Access Compliance Report Public Rights-of-Way (Curb Ramps)

Main Street: WEATHERBY_RD Cross Street: HUNTLEY_DR Location: NE

ADA ID: RPRK211217123403 Ramp Type: Type 1 - Perpendicular Diagonal Initial Pass/Fail: Pass Overall Compliance: No Severity Score: 2

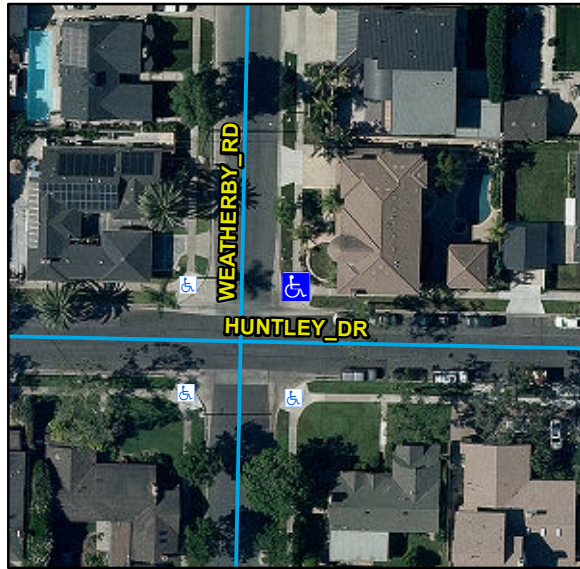
Remove & Replace Landing. Gutter Ponding Observed.

N/A	Ramp Inside Crosswalk 1	N/A	Yes	Ramp Inside Crosswalk 2	N/A
	Crossing 1 Slope (%)	4		Crossing 2 Slope (%)	6.1
	Crossing 1 Cross Slope (%)	1.9		Crossing 2 Cross Slope (%)	3.2
No	Gutter Ponding	Yes	Yes	Curb Slope	3.7
Yes	Gutter Lip Height (in)	0		Road Run Slope (%)	0.8
Yes	Gutter Run Slope (%)	0.7		Road Cross Slope (%)	1.5
Yes	Gutter Cross Slope (%)	0.7			
Yes	Overall Surface Condition: Acceptable		Yes	Perp Joint Present	Yes
	Cross Gutter Present?	Yes		Spandrel Present?	Yes
	Replace Cross Gutter?	No		Replace Spandrel?	No
